SUPREME EMBELLISHMENT LIMITED

140/1, East Baghbari, Kashimpur, Gazipur-1700

12 November 2023

Observation-7: Apparently non-engineered structures. (Shed 3, Shed 5 & Shed 6).

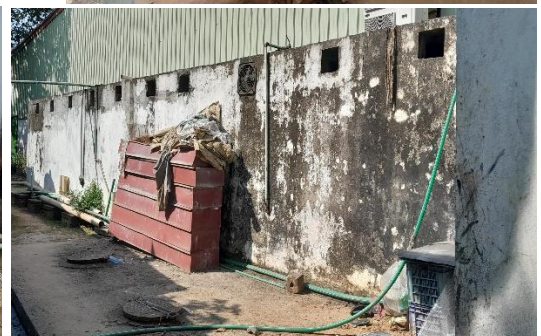
Description: Lack of lateral stability system (strut and bracing), apparent inadequate members and non-engineered connection was observed. Also, structural elements (Truss) were found cutoff at several places in Shed 5. The building engineer is required to check the member, connection & stability system of the structure and suggest proper alternatives accordingly.

11.	Apparently non-engineered structures. (Shed 3, Shed 5 & shed 6).	The building engineer is required to check the member, connection & stability system of the structure and suggest proper alternatives accordingly.	within 6 weeks

12.	Apparently non-engineered structures. (Shed 3, Shed 5 & shed 6).	Carry out suggested remedial works.	within 6 months
13.	Lack of as-built drawings (Shed 3, 5, 6, 7, ETP & Toilet block).	The building engineer required to prepare as built drawing of the Shed 3, 5, 6, 7, ETP & Toilet block.	within 6 weeks

Observation-9: Corrosion observed on steel member.

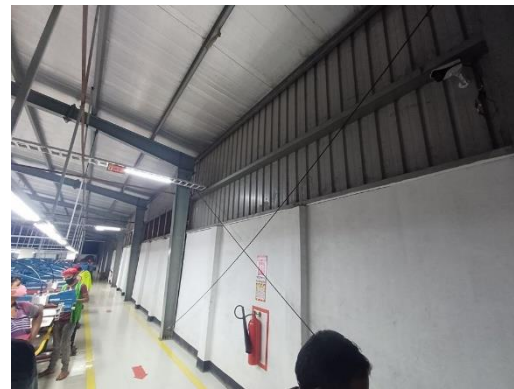
Description: During inspection, corrosion was observed on steel members at several sheds. The building engineer is required to remove corrosion and provide anti corrosive coating.

14.	Corrosion observed on steel member.	The building engineer is required to remove corrosion and provide anti corrosive coating.	within 6 months
15.	Loose cable bracing (Shed 2).	The building engineer is required to identify and tighten all the loose bracings.	within 6 months

Observation-11: Lack of anchorage/braced of non-structural elements.

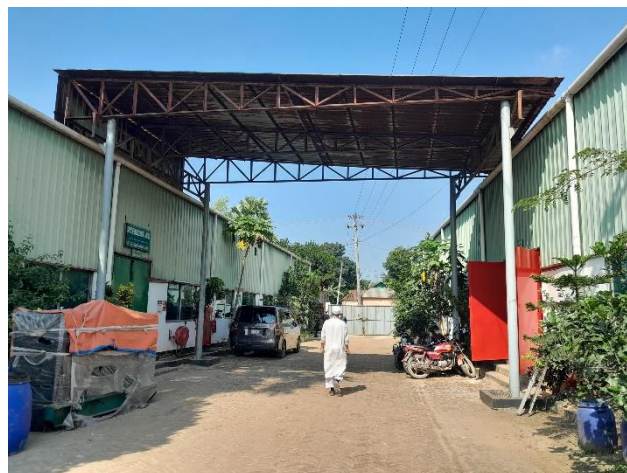
Description: During inspection, non-structural elements (Racks & water tanks) were found not anchored & unbraced. The factory is required to brace/anchor all the non-structural elements.

16.	Lack of anchorage/braced of non-structural elements	The factory is required to adequately brace/anchor all the non-structural elements.	within 6 months
